Subject: Duke Energy Carolinas, LLC  
William States Lee III Nuclear Station - Docket Nos. 52-018 and 52-019  
AP1000 Combined License Application for the  
William States Lee III Nuclear Station Units 1 and 2  
Response to Request for Additional Information  
Ltr# WLG2008.10-07

Reference: Letter from J.M. Muir (NRC) to B.J. Dolan (Duke Energy), *Request for Additional Information Regarding the Environmental Review of the Combined License Application for William States Lee III Nuclear Station Units 1 and 2*, dated August 21, 2008

**Lee Nuclear Station Response to Request for Additional Information (RAI)**

**Lee Nuclear Station Reservoir Water Surface Elevations with Broad River Pumping (82-year record)  
With Future Water Demands Included**

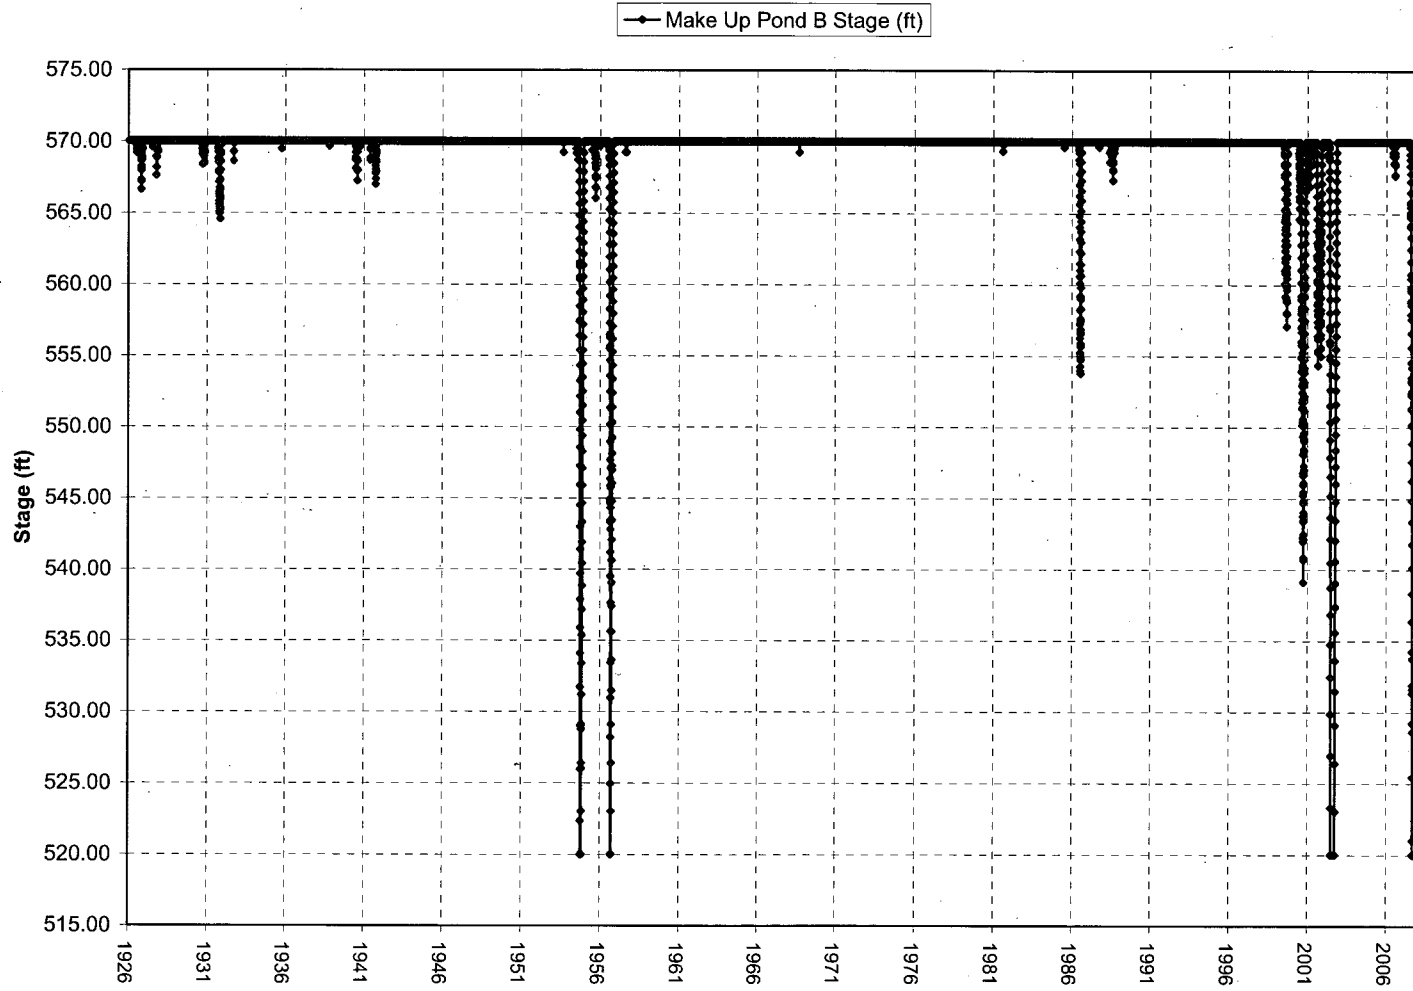
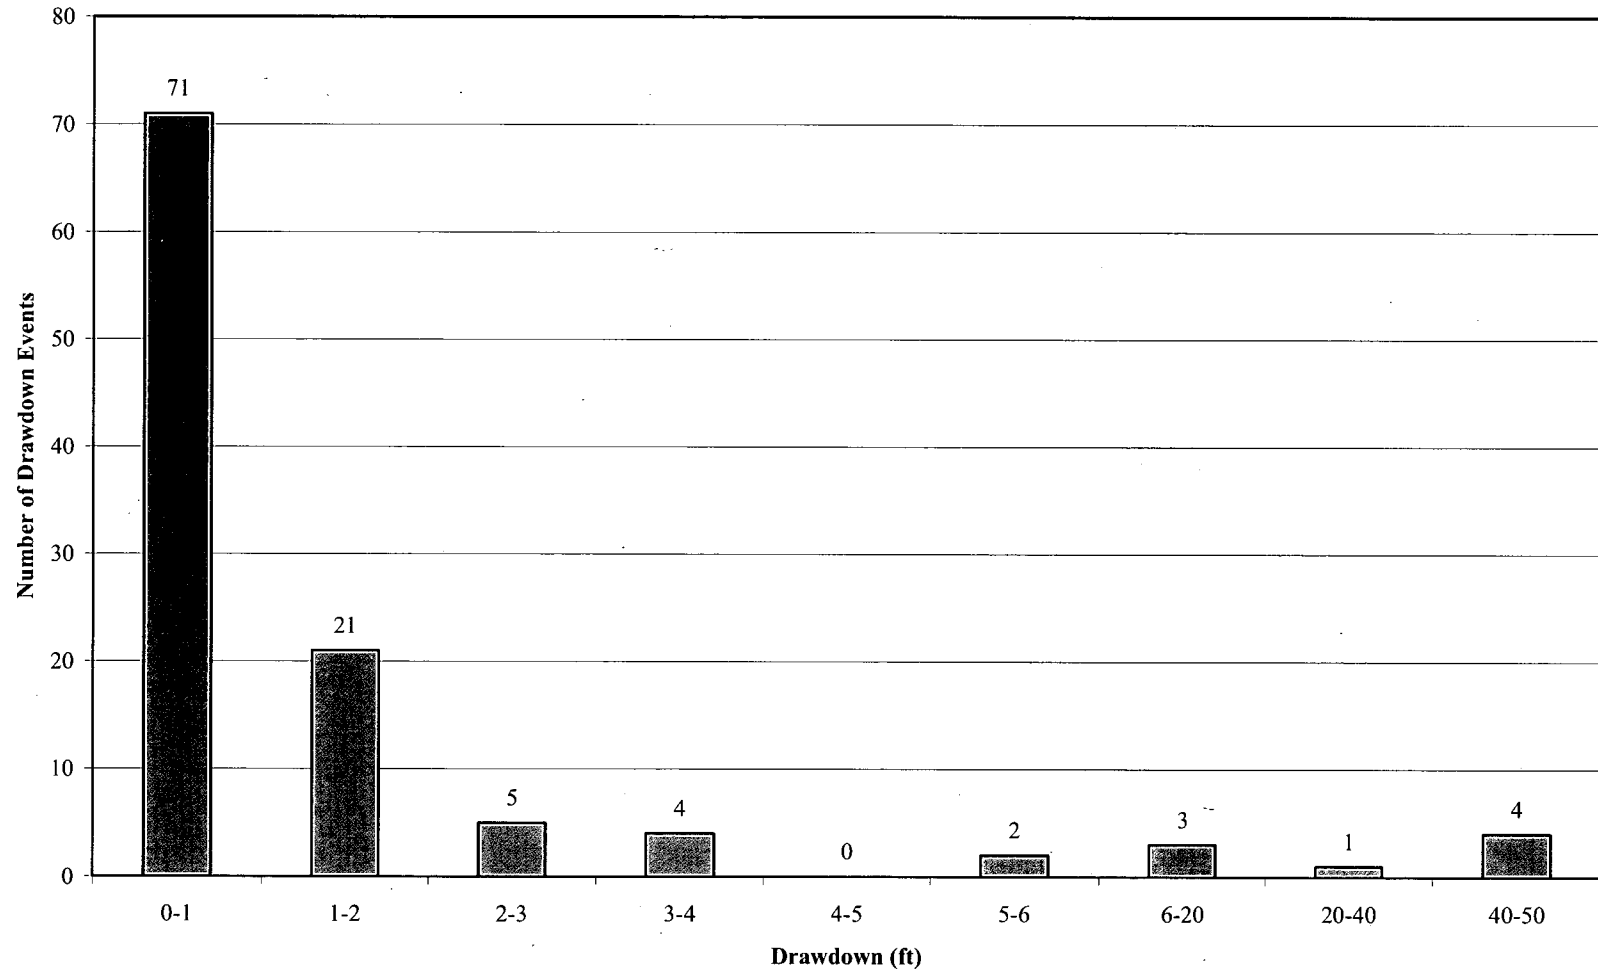
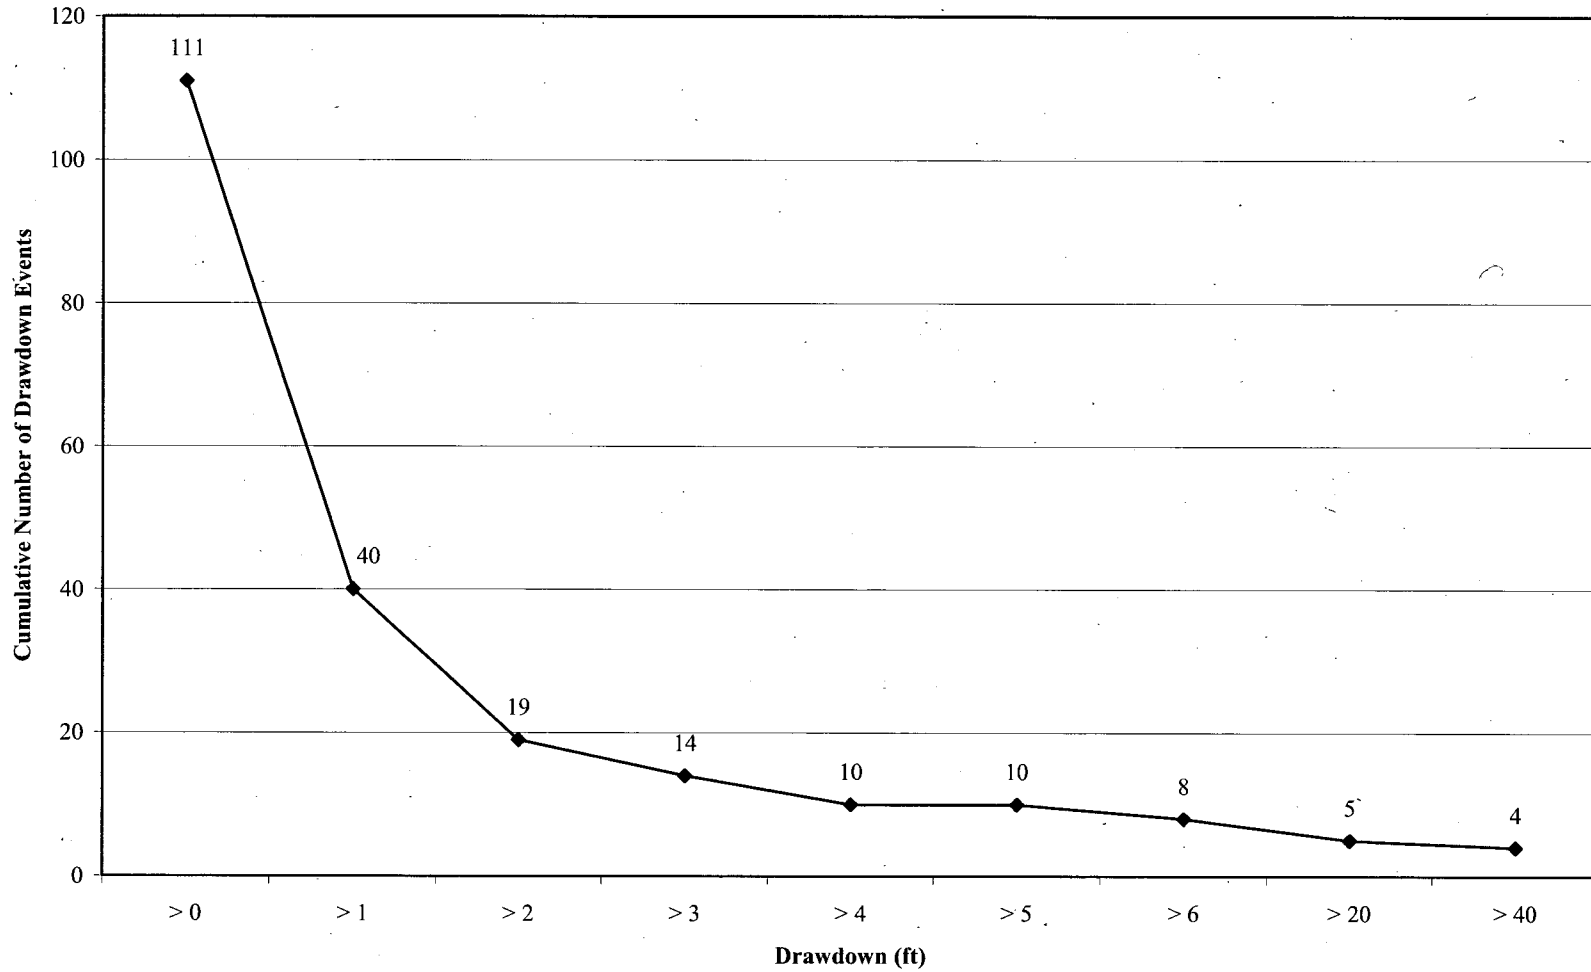
For the "Future Water Use" analysis in Environmental Report section 5.2.2.2.1 (based on an 81-year period-of-record from 1926 to 2006), provide the response of Make-Up Pond B, in terms of surface water elevation (or volume with a stage relationship so that surface water elevations can be calculated) over time (use a daily time step) during the following periods:

Also provide the response of Make-up Pond A, in terms of surface water elevation (or volume with a stage relationship so that surface water elevations can be calculated) over time (use a daily time step) during the above periods. This is in relation to evaluating impacts to wetlands.

DTA developed an Excel-based spreadsheet model to analyze the impact that low river flow conditions have on the frequency and duration of aligning to the existing Make Up Ponds A and B for supplemental make up water needs at LNS. The spreadsheet model was used to determine Make Up Pond B reservoir elevations over the 82-year period of record assuming that pumping directly from the Broad River would be limited to days where the river flow was above 588 cfs, as described above in Section 2.0. In addition, it was assumed that the maximum pumping capacity from the Broad River was 127 cfs. Figure 1 (see attachments) illustrates the predicted daily reservoir elevations for Make Up Pond B during the 82-year period of record.

Based on the modeling results, DTA determined the number of times that Make Up Pond B was used to supplement consumptive water use needs at LNS. DTA analyzed the extent of each drawdown and the number of days that it took to refill Make Up Pond B during each drawdown event. Figures 2 and 3 are histograms that show the number and magnitude of all drawdown events that occurred during the 82-year period of record. Table 1 provides details of the largest and longest duration drawdown events including the number of days to reach the maximum drawdown and the number of days it took to refill Make Up Pond B from the maximum drawdown. In all, there were 111 predicted drawdown events from 1926 to 2007. The majority of the events (71) were less than one foot in magnitude. Four of the events were 50-foot drawdowns, which completely emptied Make Up Pond B of all usable storage. The most severe drawdown event was during 2007, lasting a total of 204 days. During this event, Make Up Pond B was empty for 100 consecutive days. Once Broad River flows increased to the point where pumping from the river could resume, it took a total of 42 days for Make Up Pond B to fully recover from this drawdown event.

**ER Figure 2.4-2, Wetlands on the Lee Nuclear Site**

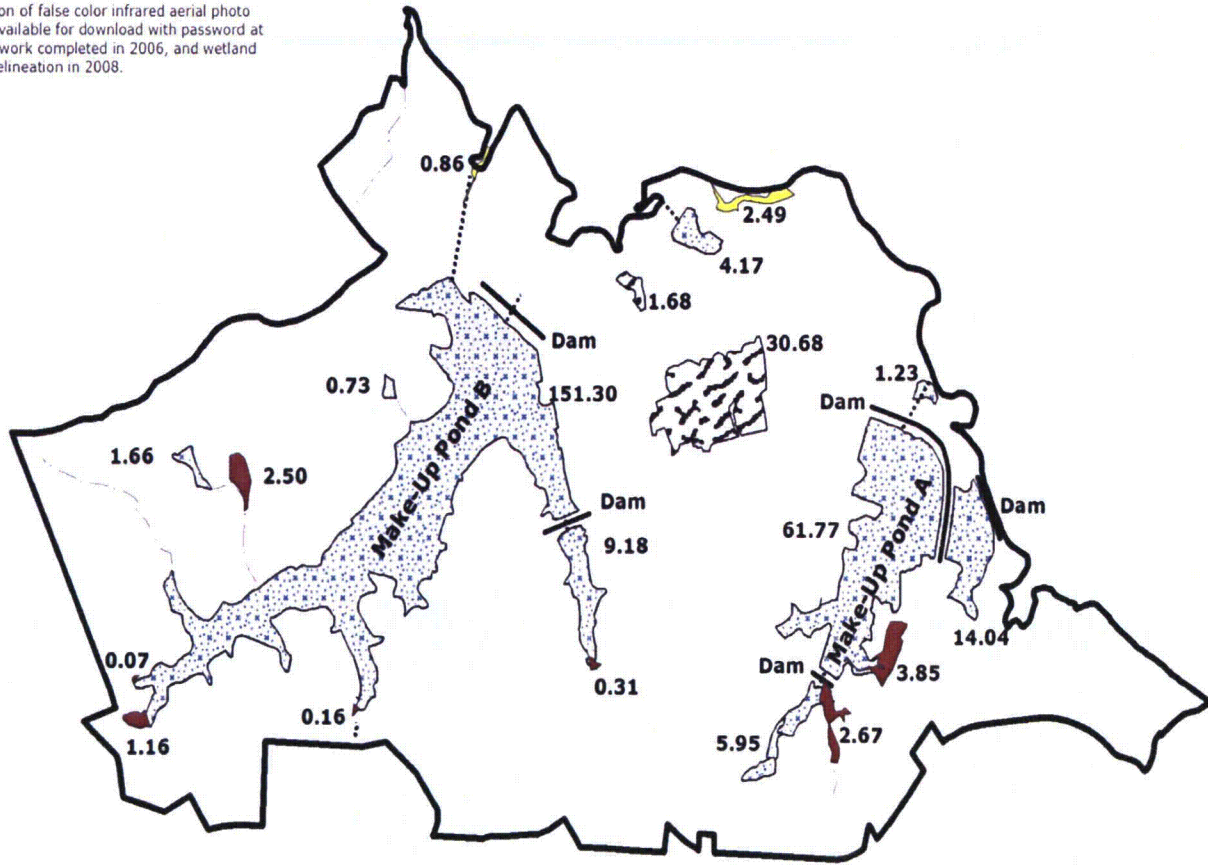
16. Revise COLA Part 3, ER Chapter 2, by adding a new Figure 2.4-2, as shown in Attachment 97-1.
  17. Revise COLA Part 3, ER Chapter 2, Table 2.4-1, as follows:

At the Lee Nuclear Site, wetlands occupy a total of 46.442-8 ac. or 2.42-3 percent of the site (Figure 2.4-2 ~~Figure 2.4.1~~). They are currently represented by Alluvial Wetland, Nonalluvial Wetland, and Nonjurisdictional Wetland that total 3.22-3 ac. (0.2+2 percent), 10.88-1 ac. (0.643 percent), and 32.4 ac. (1.7 percent) of the total site area, respectively (Table 2.4-1).

Two~~One~~ small areas~~areas~~ of alluvial wetland currently exists on the northern border of the site (Figure 2.4-2 ~~Figure 2.4.1~~). The first is about 2.5 ac. in area and is located immediately upstream of ~~near~~ the proposed water intake structure on the river. The second, about 0.8 ac. in area, is located further upstream at the bottom of a spillway channel that drains overflow water from Make-Up Pond B. At both locations, ~~Here~~ cottonwood, sycamore, sugarberry, sweet gum, and green ash form the canopy. Box elder, black willow, and buttonbush are found in the understory. False nettle, river oats, and cane occupy the shaded herbaceous layer of these ~~is wetlands~~ wetland.

**ER Figure 2.4-3, Approximate Locations of Fish Collection Stations on  
the Broad River in Proximity to the Proposed Lee Nuclear Site**

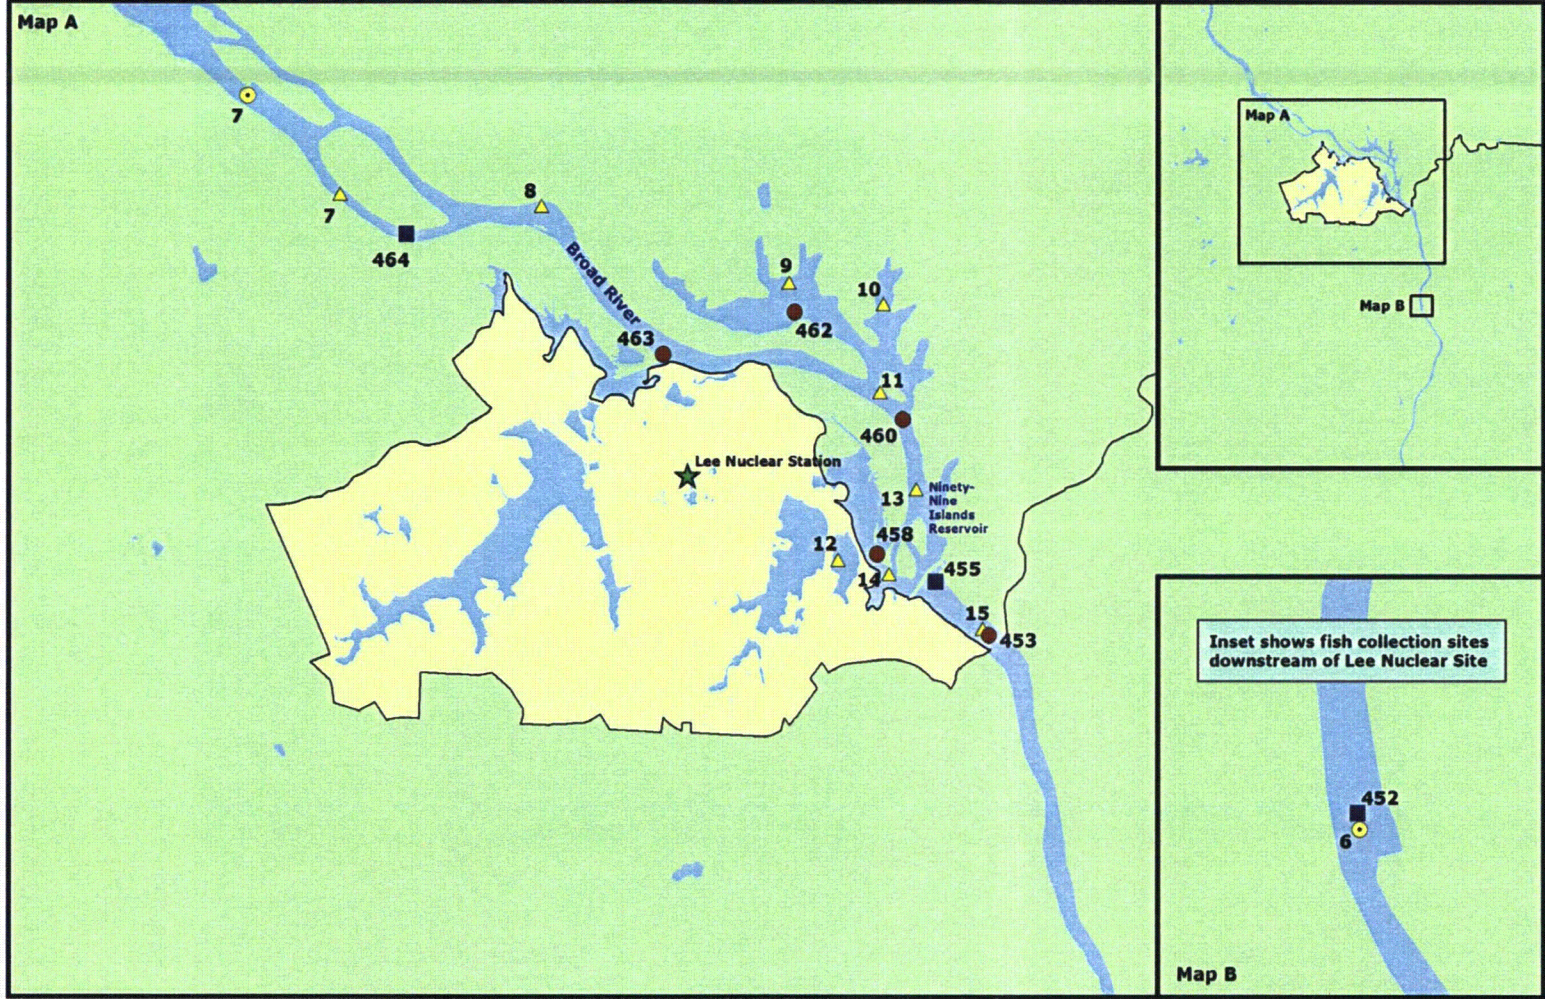
- b) Also reported in References 5 and 38.
    - c) Also reported in either Reference 5 or Reference 38.
  15. Revise COLA Part 3, ER Chapter 2, by renumbering Figure 2.4-2 to Figure 2.4-3, as shown in Attachment 97-2.

11. Revise COLA Part 3, ER Chapter 2, Subsection 2.4.2.3, Page 2.4-27, replace the figure reference, as follows:  
 The habitats sampled at Locations 453 and 465 (see ~~Figure 2.4-2~~ Figure 2.4-3) were generally similar, consisting of locations near islands in the river with large riffle areas, tree root masses, leaf packs, and small sand/cobble substrates. Locations 459, 460, and 463 within Ninety-Nine Islands Reservoir were also similar to each other in habitat, which was limited by steep banks, some root masses along the bank, and organic matter on the bottom.

14. Revise COLA Part 3, ER Chapter 2, Page 2.4-56, Footnote to Table 2.4-8, as follows:
    - a) See ~~Figure 2.4-2~~ Figure 2.4-3 for sample station locations.
